# Access Compliance Report

## Public Rights-of-Way

| Intersection ID: 10036062               | Main Street: RIVERGATE_PY | Cross Street: N/A                       | Location: NW           |
| ADA ID: D3FA65B6B32B                    | Ramp Type: PerpDiag       | Initial Pass/Fail: Fail                 | Overall Compliance: No |

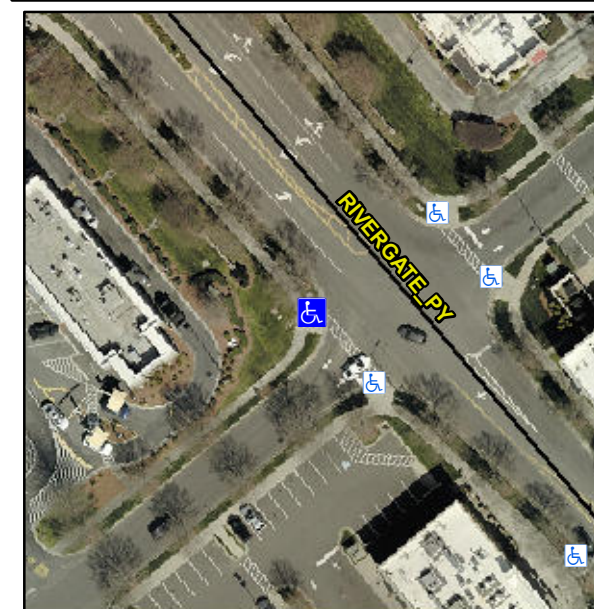
**Not Found, R304.5.1, R304.5.3**

| Compliance | Description           | Data | Compliance | Description                 | Data |
|------------|-----------------------|------|------------|-----------------------------|------|
| N/A        | Ramp Length (in)      | 97.0 | Yes        | Ramp Slope (%)              | 7.9  |
| No         | Ramp Width (in)       | 45.0 | No         | Ramp XSlope (%)             | 2.5  |

**Remove & Replace Curb Ramp With Two New Directional Ramps or Equivalent.**
